SAFETY RECALL BULLETIN

NHTSA RECALL 20V450

AUTOCAR, LLC SAFETY RECALL ACX-2004

Inspection and/or reinstallation of the parking brake synchronization valve (synchro valve) on certain Xpeditor chassis.

Figure 1

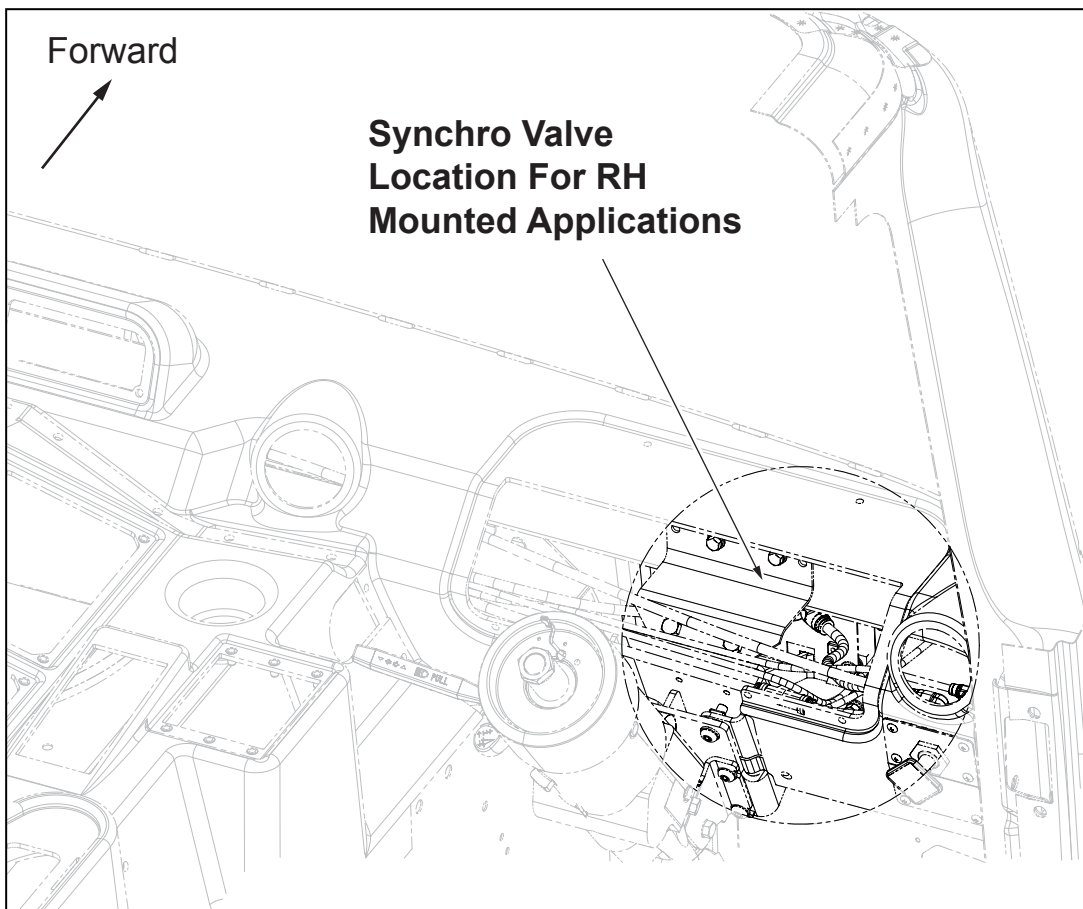
1. Unlock and open the right door.
2. Locate the synchro valve (see Figure 1).

Note: It may be necessary to move the wiring harness to obtain a clear view.

Figure 2

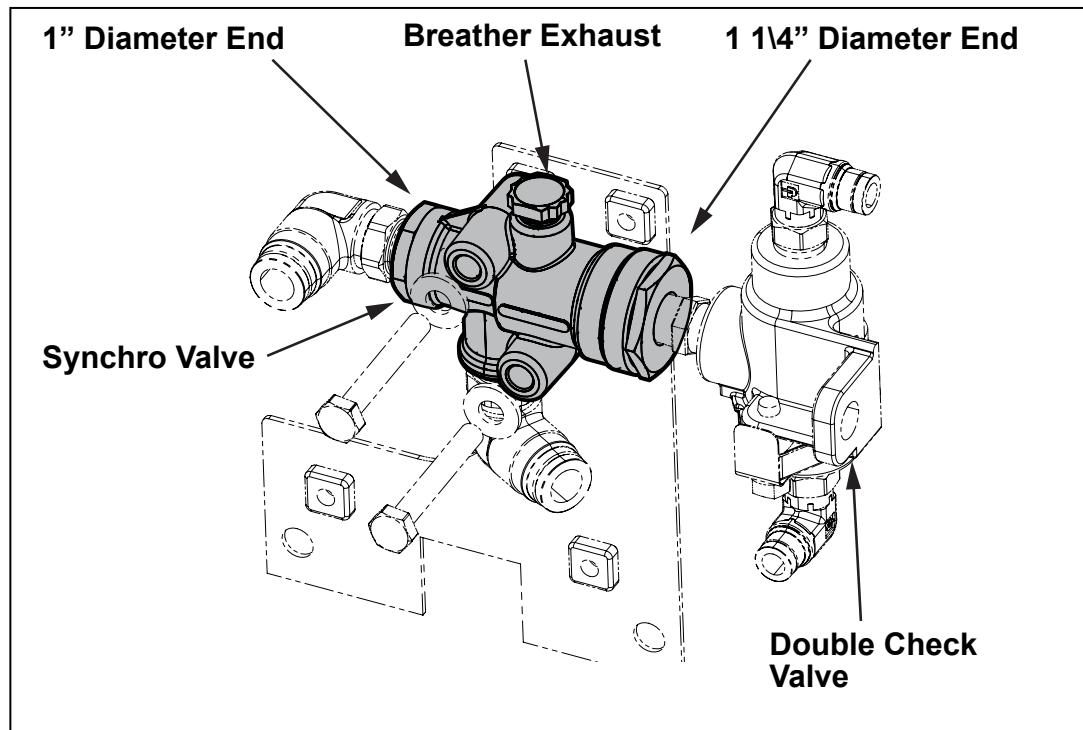
3. Ensure that the larger 1-1/4" diameter end of the synchro valve is to the right and connected to the double check valve (see Figure 2).
4. Ensure that the upper bolt and narrow end (1") of the synchro valve is to the left of the exhaust breather (see Figure 2).

5. If the orientation of the synchro valve is found to be correct, the inspection is complete. If, the orientation is found to be the incorrect, proceed to step 6.

Figure 3

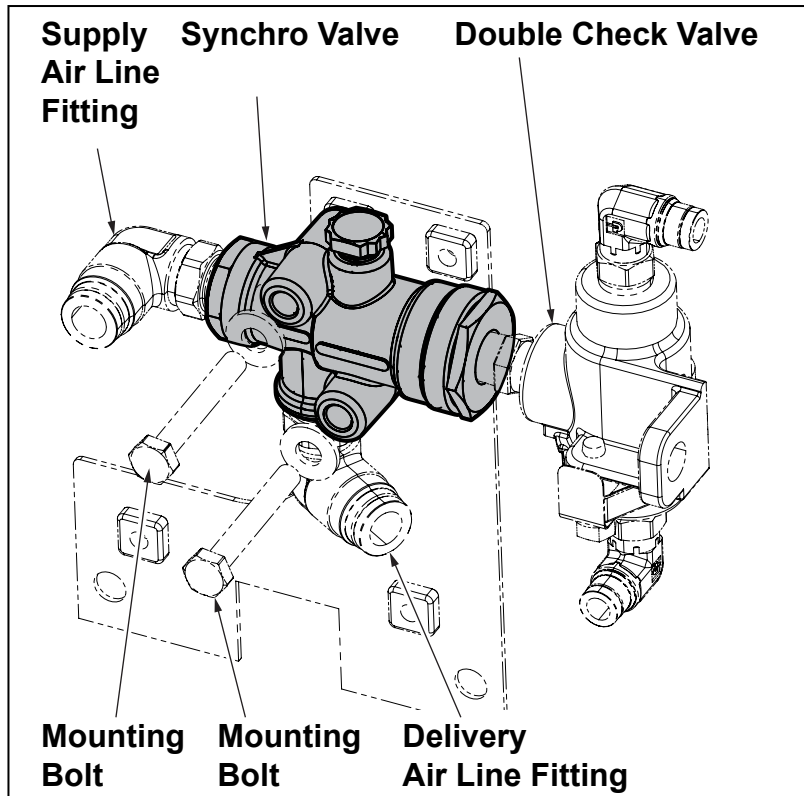
6. Disconnect all of the air lines from the synchro valve and the double check valve assembly.
7. Remove the valve assembly (synchro and double check valve) by removing the 2 mounting bolts and set the mounting bolts aside for reinstallation (see Figure 3).

8. Separate the synchro valve from the double check valve and place the double check valve aside for reassembly.
9. Remove the air line fittings from the 1" and 1-1/4" ends of the synchro valve and set aside for reinstallation (see Figure 3).

10. Rotate the synchro valve to the correct position.
11. Apply paste or liquid pipe thread sealant (obtained locally) to the threads and reinstall the air line fittings into the synchro valve.

12. Apply paste or liquid pipe thread sealant (obtained locally) to the threads and reassemble the synchro valve to the double check valve that was set aside in step 8.

13. Reinstall the synchro valve and double check valve assembly by reconnecting the air lines that were disconnected in step 9 (see Figure 3).
14. Reinstall the 2 mounting bolts that were set aside in step 7.
